Coal Combustion Waste Impoundment

Round 7 - Dam Assessment Report

Walter Scott Junior Energy Center

MidAmerican Energy
Council Bluffs, Iowa

EXHIBIT 1: REPRESENTATIVE SECTION OF NORTH ASH POND LEVEE EMBANKMENT (South Side at Outlet Works)

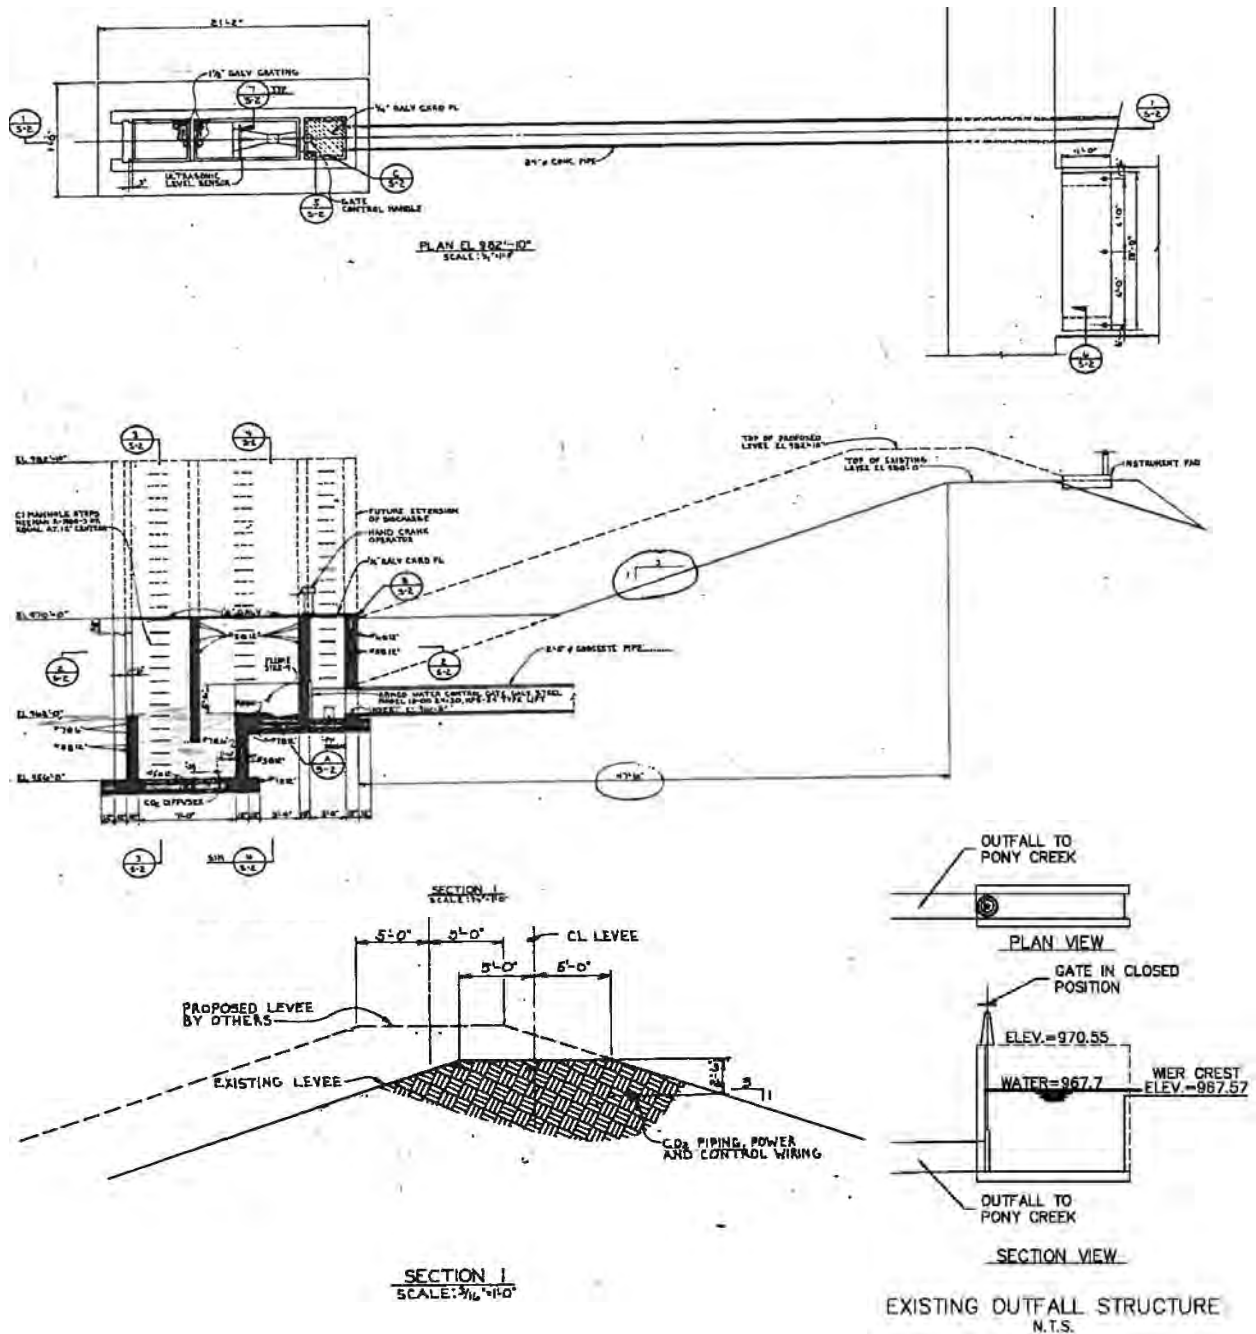
horizontal (H) to 1 vertical (V) side slopes. The final design grades of the levees and dikes of the North Ash Pond are shown on the Finish Grades plans in Appendix C - Doc 1.3. However, the crest of the south side levee is actually about 3 feet higher than shown on the Finish Grade plans. MidAmerican indicated that the USACE raised the Mosquito Creek and Pony Creek levees in the early 1980s, and the change in height resulted in a slope of the crest from elevation 982 feet to 983 feet. However, a recent survey of crest elevations around the perimeter of the pond suggests that the Mosquito Creek levee was not raised (see Appendix D - Item 2).

DOC 1.3 FINISH GRADES PLANS

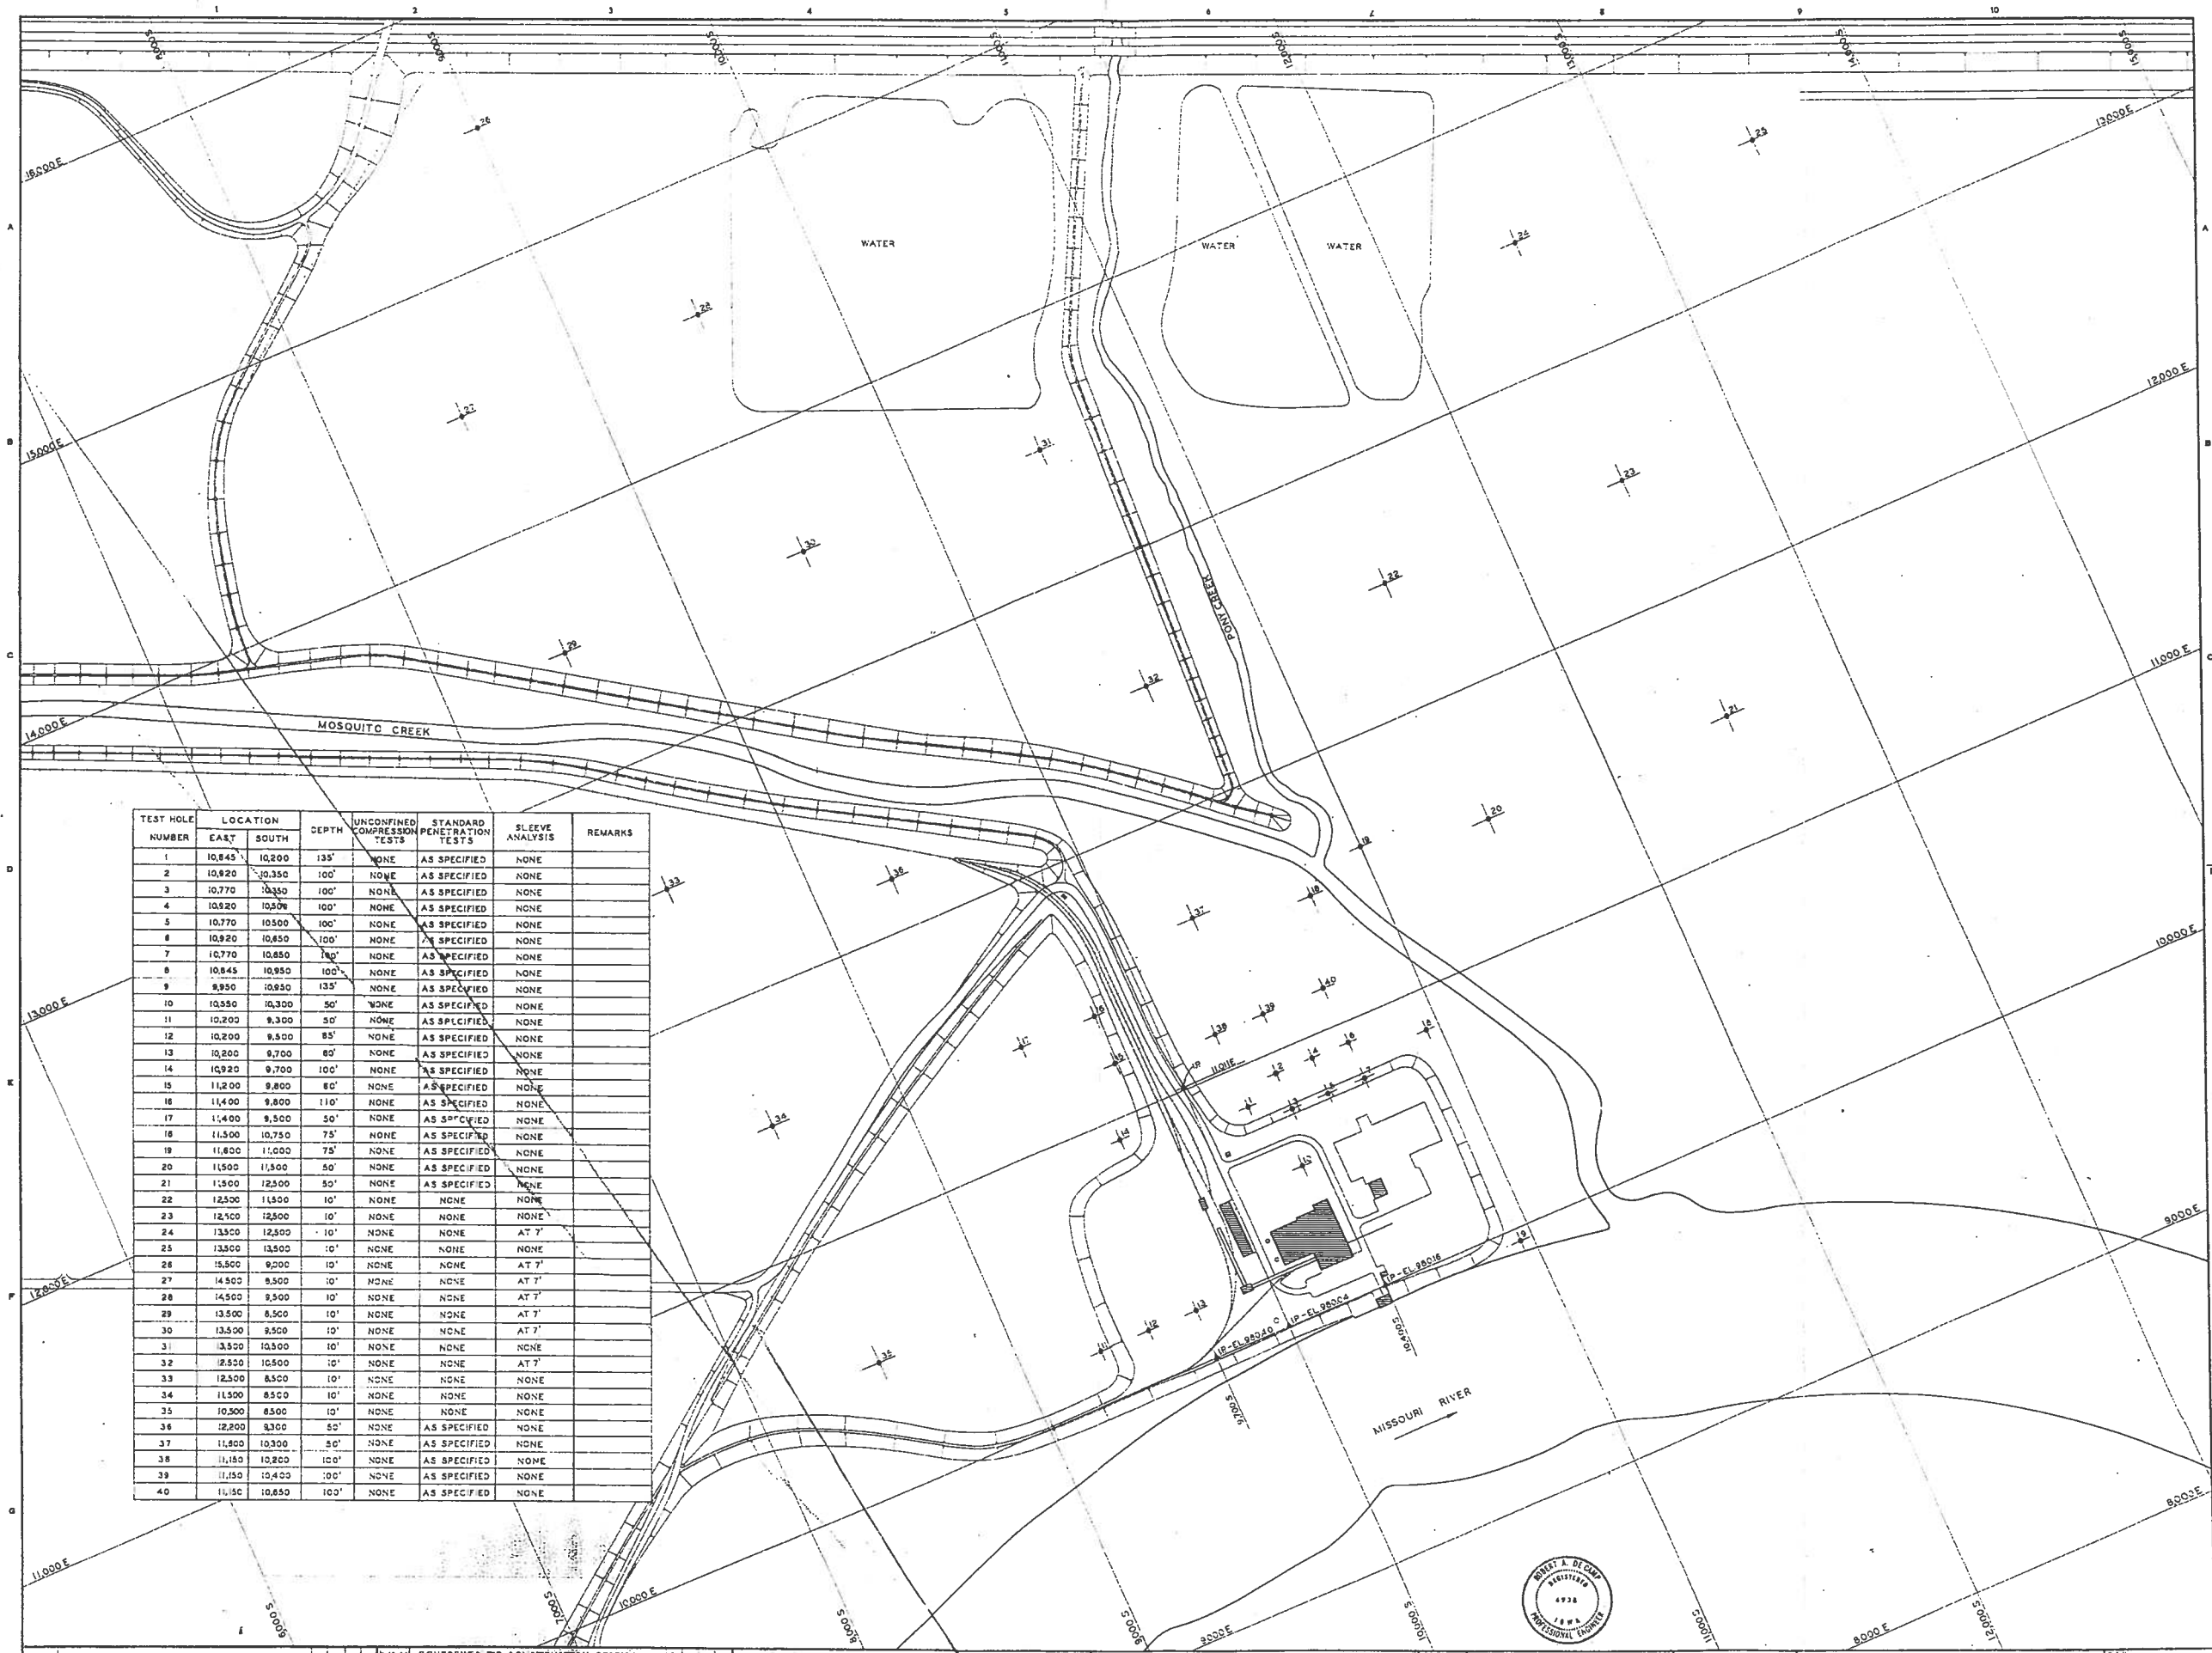
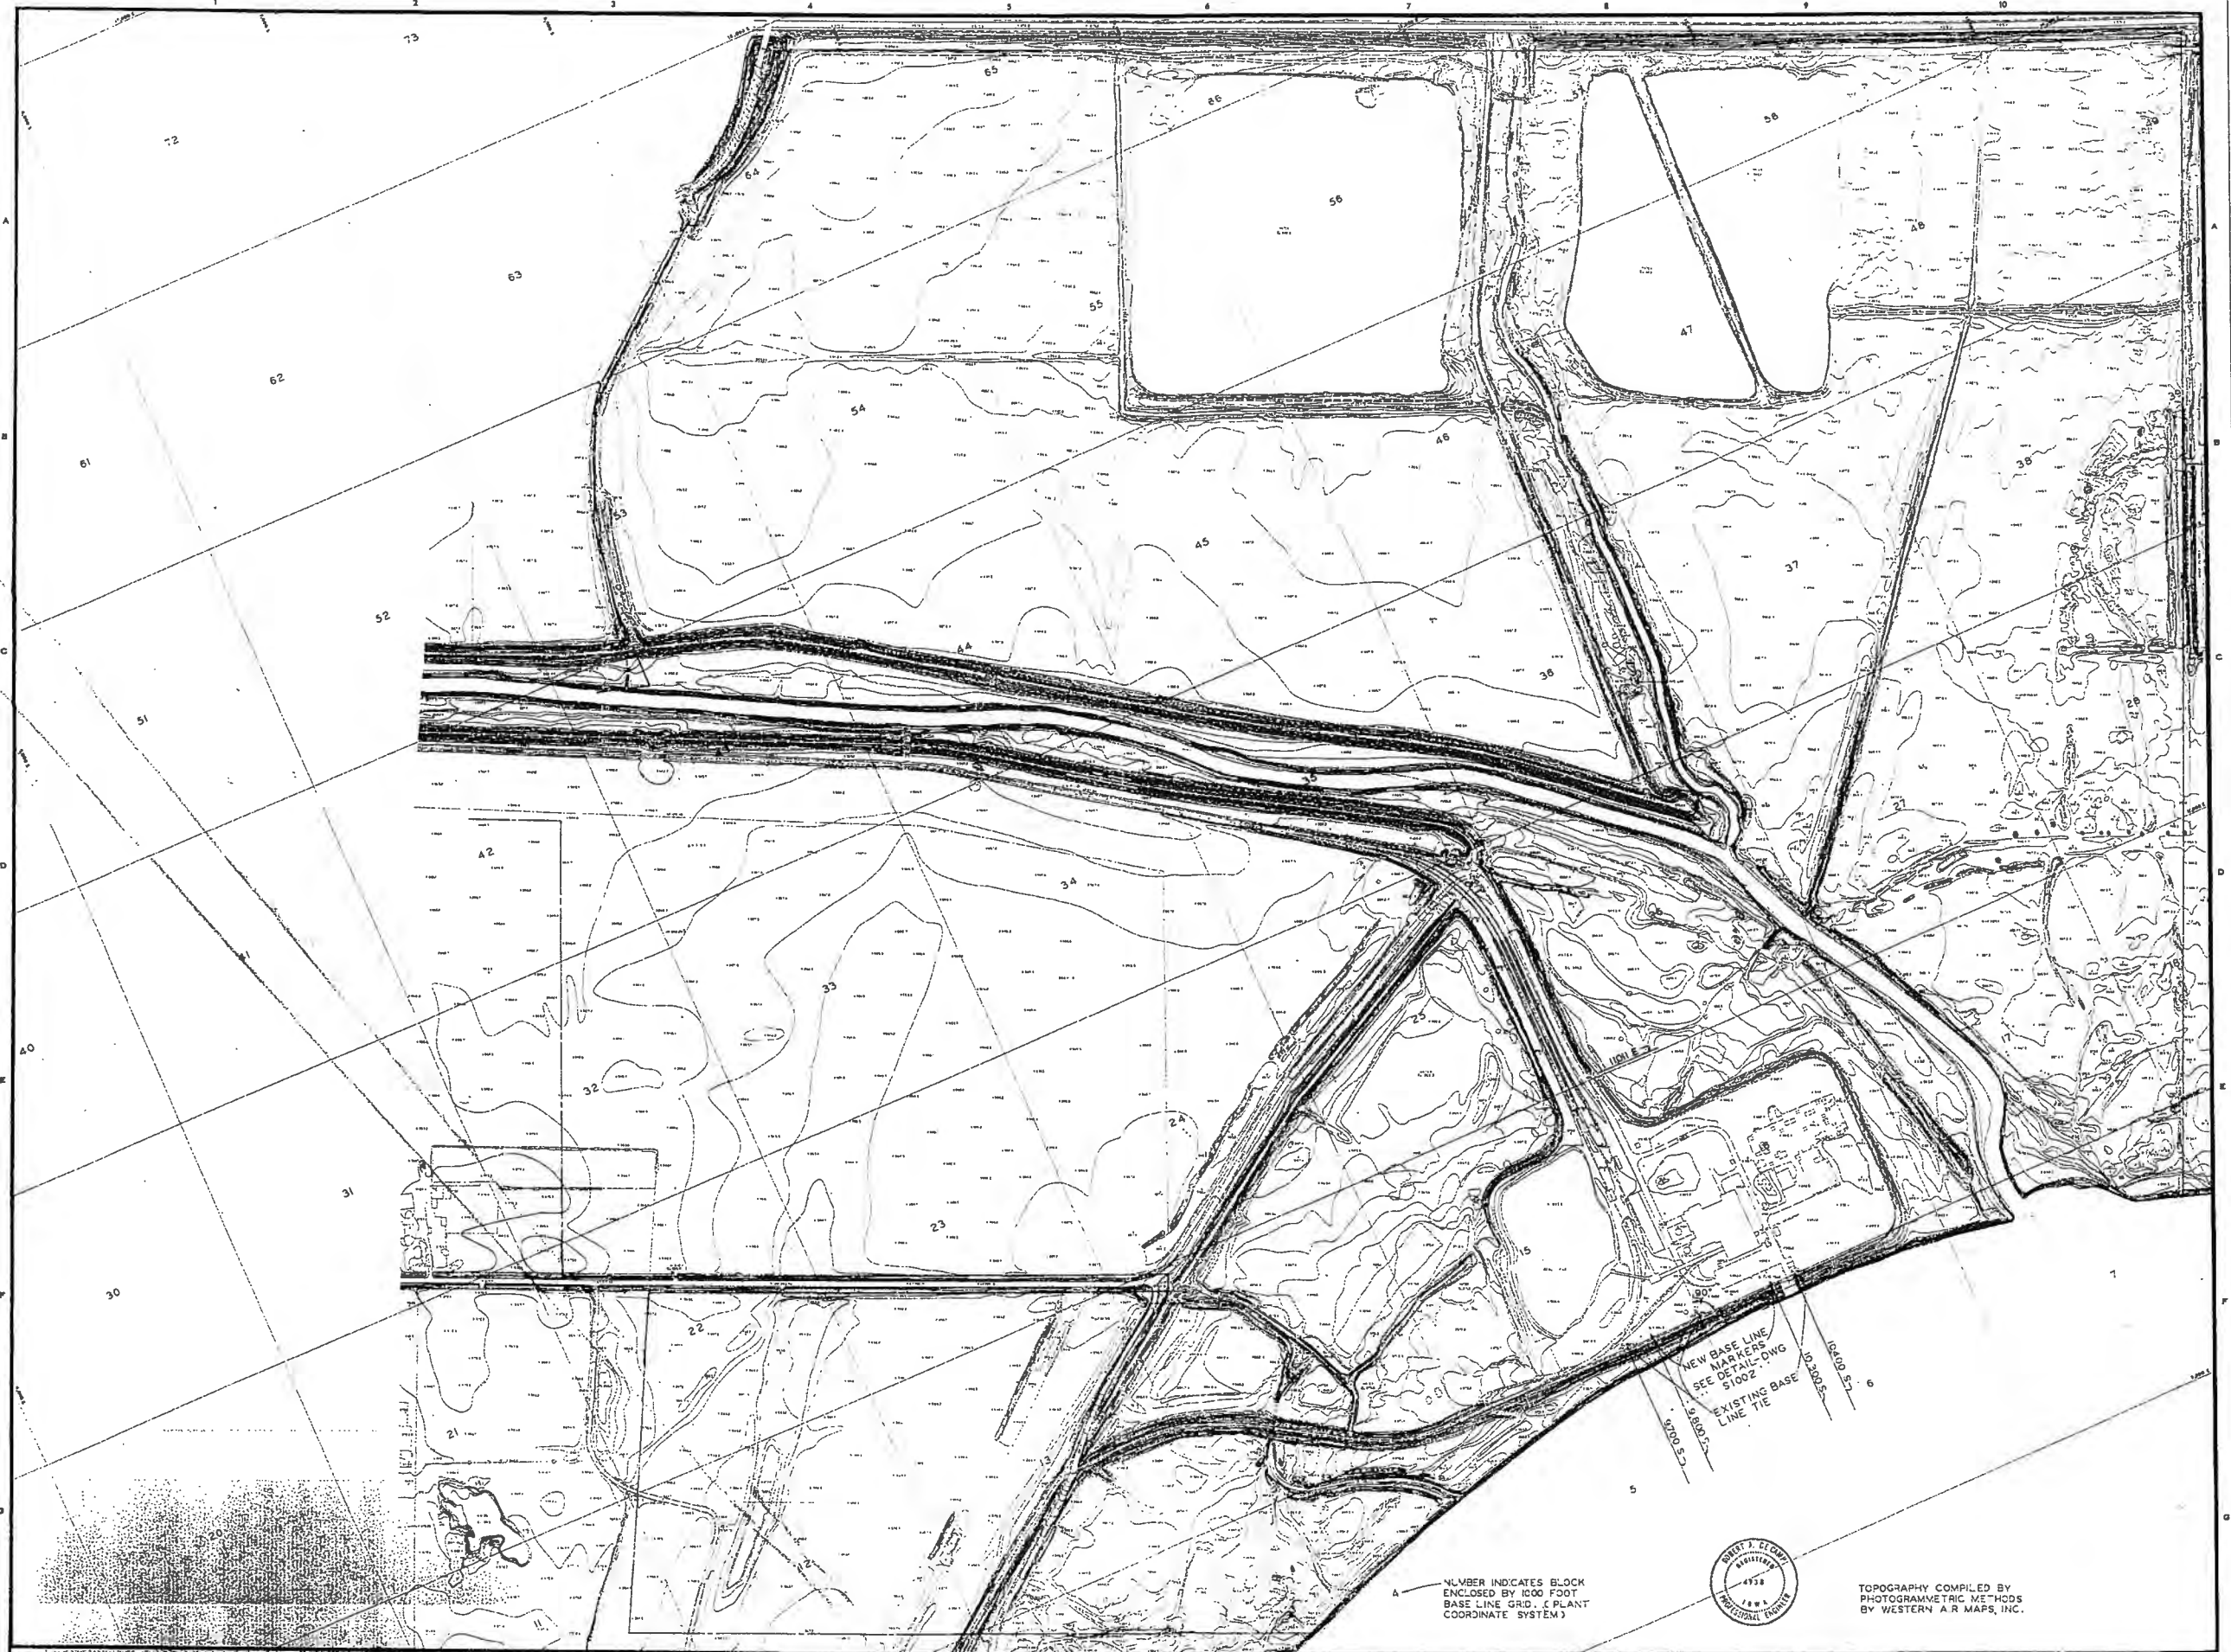
Supporting technical documents are generally adequate for the purposes of this review and assessment, although furnished drawings show original design features and do not reflect as-built features or all modifications that have been made since original construction (e.g., the SIRE railroad embankment built across the western part of the ash basins does not show on any of the furnished drawings).

Descriptions provided are generally sufficient. As noted above, furnished drawings do not show or note as-built features or all modifications that have been made since original construction.

Update project documents to include or note current features of the ash basins and modify or supplement the documents as needed when changes are made in the future. For example, the recently completed crest elevation profiles around both ash ponds surveyed by HGM Associates, Inc. (Appendix D - Item 2) serves to provide documentation of current crest elevations, which should be referenced on official project plans.
